037-124-014

CE13-0012

211 THERESA STREET

CODE ENFORCEMENT OFFICER

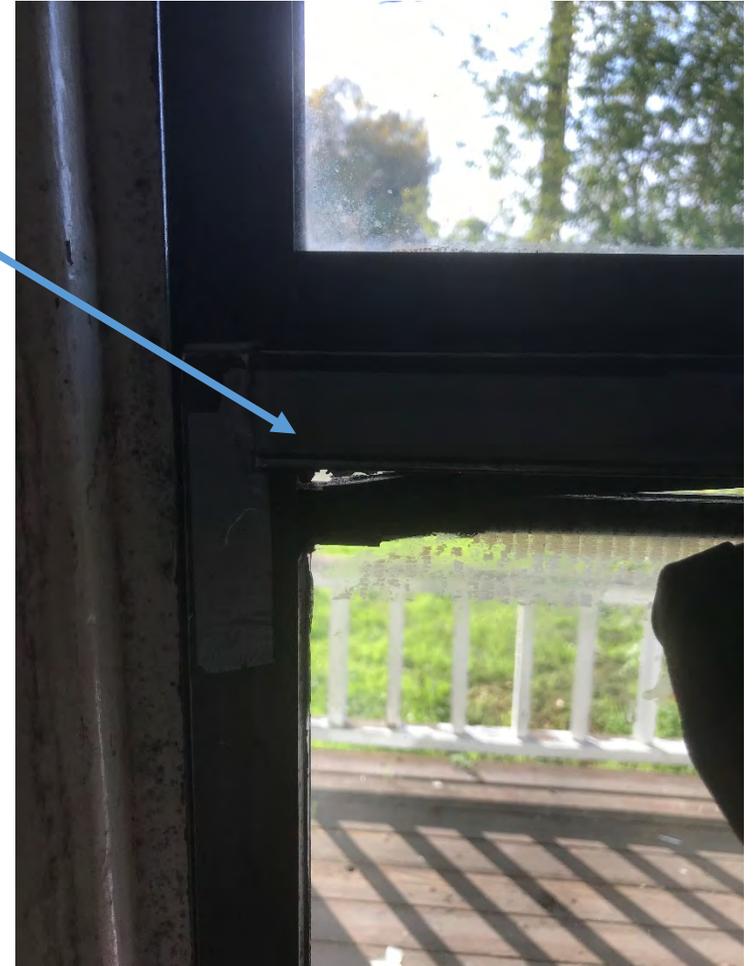
211 Theresa St
Window seal is not weather tight
Living room window

211 Theresa St
Glazing broken

211 Theresa St.
Combo Smoke detector and carbon monoxide detector
Keyed locks on both bedrooms

211 Theresa St
Mildew on bathroom ceiling and wall

211 Theresa St
Inoperable and unregistered vehicle

Unapproved materials used to cover detached garage walls
penetration in fire rating, required 5/8 or 1/2 inch gypsum board

Detached garage door covered without benefit of permit

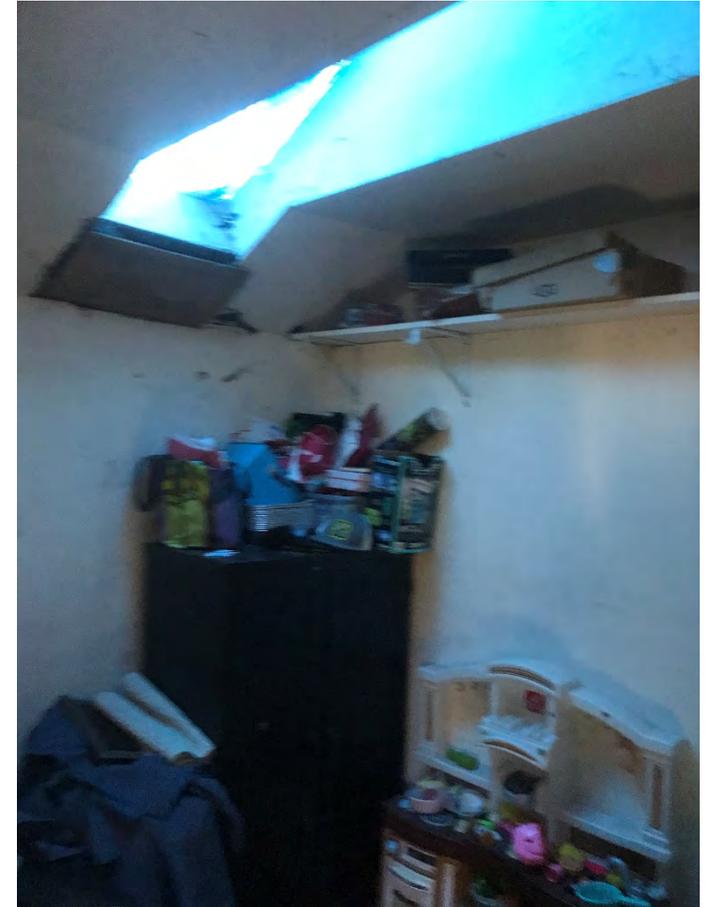
water intrusion at skylight

Foam spray and particle board surrounding wall base in detached garage

211 Theresa St
Penetration in fire rating requires 5/8 or 1/2 inch gypsum board
Water intrusion

211 Theresa St
glazing broken in window glazing

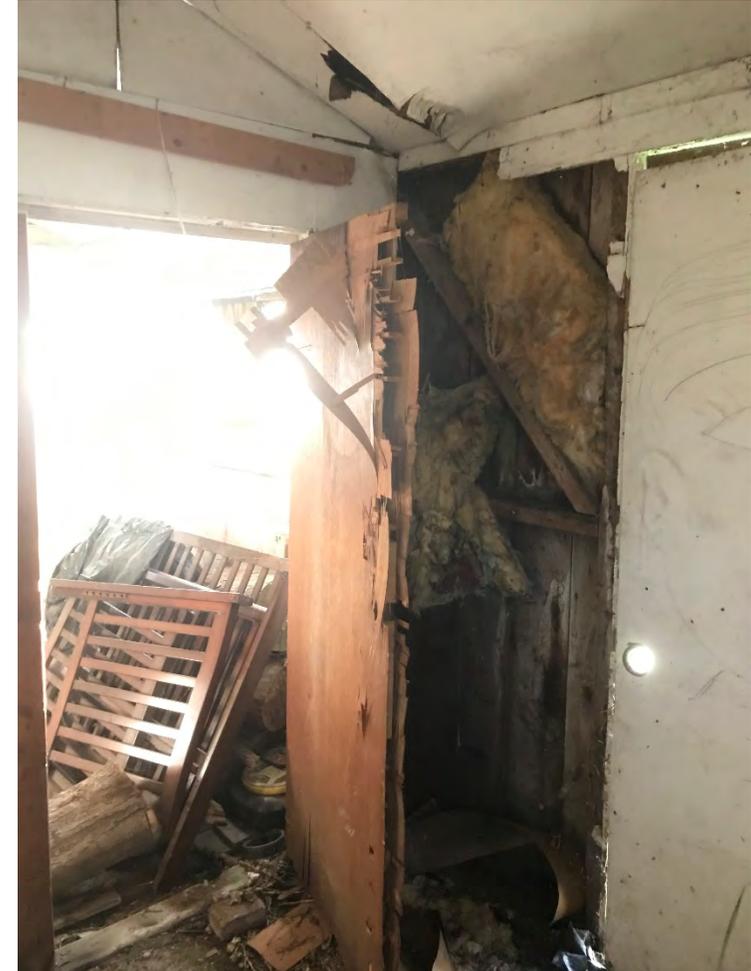
Existing accessory structure with unpermitted electrical

211 Theresa St
Unpermitted electrical in existing accessory structure

211 Theresa St
Unpermitted electrical throughout detached structure
